# **RENESAS TECHNICAL UPDATE**

Product Category	Transistors		Document No.	TN-WTR-A003A/E	Rev.	1.00
Title	PCN of Packing for TO-220CFM Power Transistors		Information Category	Packing change		
Applicable Product	All of TO-220CFM	Lot No.	Reference Document

# 6.1. Form of Tube for TO-220CFM

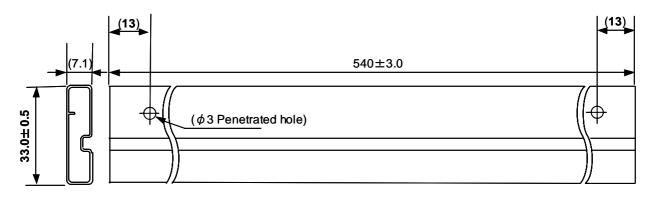
The packing tube for TO-220CFM will be changed by the item 6.1.

# [After the change]

# [Before the change]
